**JOINT REGIONAL PLANNING PANEL
(Eastern Region)**

JRPP No	2011SYE075
DA Number	DA/494/2011/A
Local Government Area	Randwick City Council
Proposed Development	Section 96 modification of the approved student accommodation development, including the addition of a loading bay, installation of an additional car park lift, a minor reduction in the north-east corner building alignment, a reduction in the northern deck at ground floor level, alterations to steps/ramps on the western elevation, alterations to exterior doors, replacement of louvres with fixed glass, replacement of batten screens with balustrades, deletion of Juliet balconies on the southern walls, installation of planters in through-site link and various amendments to the internal layout.
Street Address	330 Anzac Parade, KENSINGTON
Applicant/Owner	/University of NSW
Number of Submissions	None
Recommendation	Approval
Report by	Environmental Planning Officer – Randwick City Council

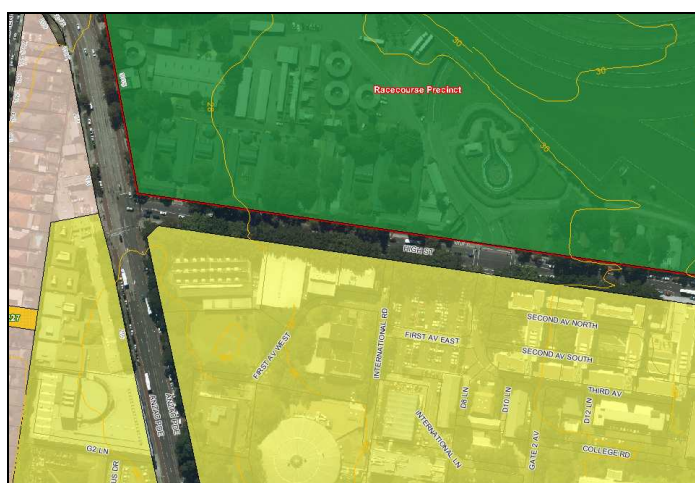
- The removal of 28 south facing Juliet balconies - The reason given for their removal was that the balconies were only 300mm wide and added little amenity. The Panel accepts that the balconies were compromised however their removal reduces the articulation of the south facade and reduces that weather protection to the southern windows (previous Panel comments prior to Development Approval included the recommendation for added articulation to the southern elevation). The Panel recommends that weather protection hoods or the like be provided in lieu of the balconies.

Assessing Officer Comment: Additional window diagrams were submitted to Council on 14 February 2012. The statement that the deletion of the Juliet balconies will enhance articulation is supported, given that the Juliet balconies were to be constructed using solid materials and will be replaced instead by selected masonry brickwork; which is shown in the Schedule of Finishes submitted with the original application.
